JLRTB02061NAS1

**TECHNICAL BULLETIN**

Amber 'Low Coolant' Warning Message Displayed On The Instrument Panel Cluster (IPC)

Engine coolant level sensor loose.

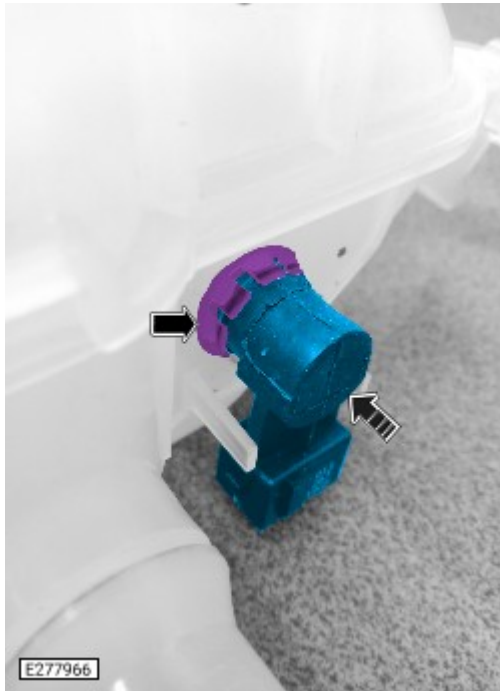
Make sure the engine coolant level sensor is fully located in the engine coolant expansion tank.

Make sure the ratchet section of the cable tie is positioned in the direction shown in the illustration.

Install a cable tie around the engine coolant level sensor, just before the retaining tabs.

Make sure the ratchet section of the cable tie is positioned in the opposite direction to the first cable tie, as shown in the illustration.

Install a second cable tie around the retaining tabs of the engine coolant expansion tank.
